EREC G5 Stage 2 Sub-group

Meeting No. 6

Meeting Notes

Draft Fig 2 – New Analysis Spreadsheet

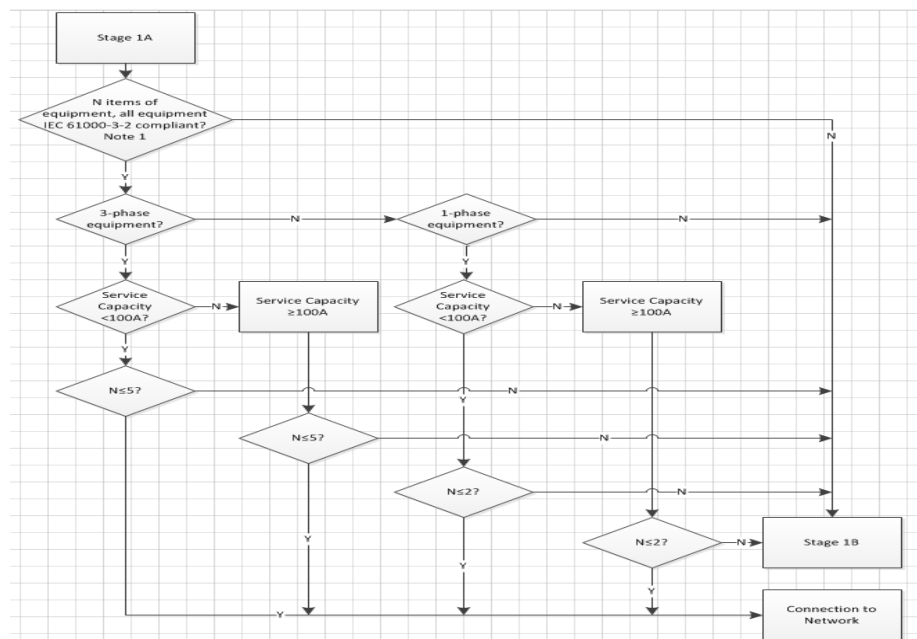
SPS showed the resulting revision to the draft Fig 2 Flow Chart, assuming one connection is allowed to use the whole allocated G_{hLV} .

<p>SPS asked for any thoughts on how this could be improved. It was agreed that the values derived in this manner would be adopted provisionally for each connection rather than reduced to allow for multiple connections; it was agreed this was reasonable given that:</p> <ul style="list-style-type: none"> i) The numbers permitted are small ii) The assumed position of the connections is lumped together at Zref – in reality, connections may be distributed, iii) Impedance could be less than Zref iv) Emissions could be lower than the maximum permitted by IEC 61000-3-2 v) Existing voltage distortion could serve to reduce emissions. vi) Failure of Stage 1A advances to Stage 1B and so on. <p>SPS to proceed on the basis that the above is satisfactory and draft the text accordingly.</p>	All

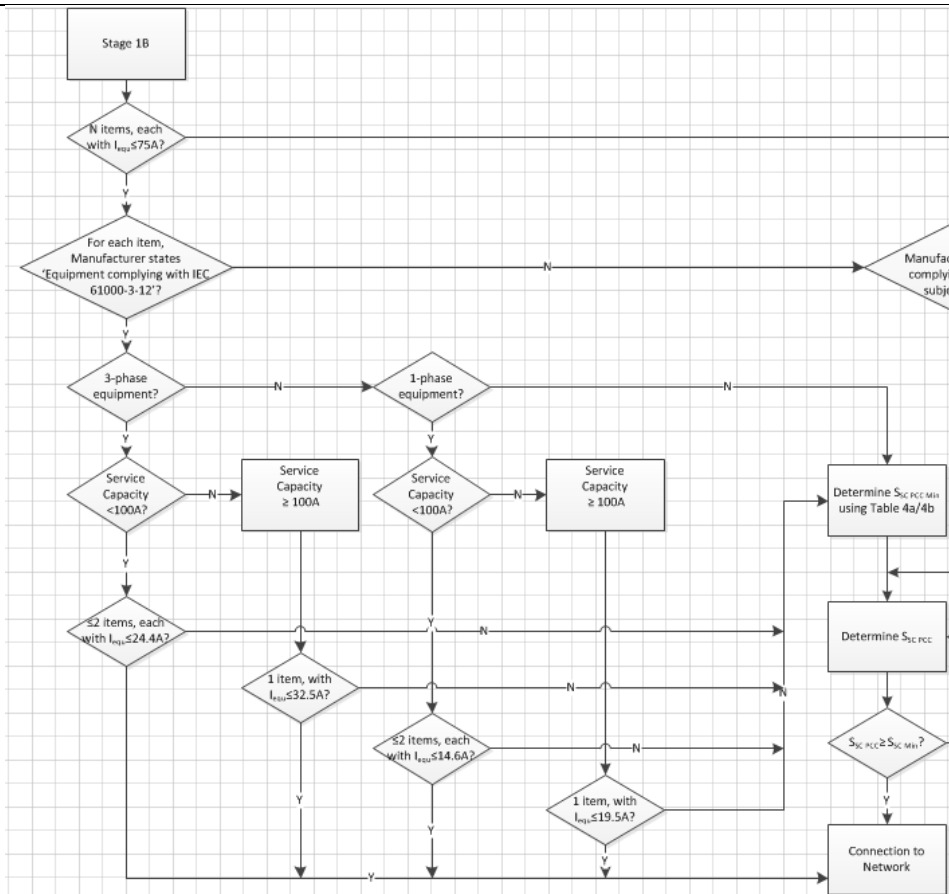
4.4	<p>Draft Fig 3 – New Analysis Spreadsheet</p> <p>SPS explained the spreadsheet entitled: ‘61000-3-12 Further Analysis rev1’.</p> <p>This analysis looks at the maximum equipment rating that satisfies a voltage change limit (phase-neutral) of 3% for reference impedance – see cell K4. It then uses that to derive current emission (Column B) for a single item of equipment. Column G gives the voltage distortion created by one such piece of equipment.</p> <p>Column K gives the maximum Global contribution from the LV, G_{hLV}, system taking account of the LV and HV planning levels - PL_{LV} and PL_{HV} - and assuming transfer from HV using a transfer coefficient, T, of 1.0 and summation exponent, α:</p> $G_{hLV} = \sqrt[\alpha]{PL_{LV}^\alpha - (T \cdot PL_{HV})^\alpha}$ <p>Column L gives G_{hLV} as a % of PL_{LV} calculated from the above equation.</p> <p>Column M gives the allocated G_{hLV} as a % of PL_{LV}, notwithstanding the calculated G_{hLV}. Column N explains the basis of the allocated value where this differs from Column L.</p> <p>Columns R, T, V, X and Z give the voltage distortion for increasing number of items, N, from N=2 to N=6. Columns S, U, W, Y and AA give the comparison of the combined voltage distortion with the allocated G_{hLV}.</p> <p>SPS showed the resulting revision to the draft Fig 3 Flow Chart, assuming one connection is allowed to use the whole allocated G_{hLV}.</p>	SPS

SPS explained that this needs to be further improved to permit larger numbers of devices with smaller equipment ratings (down to 16A).
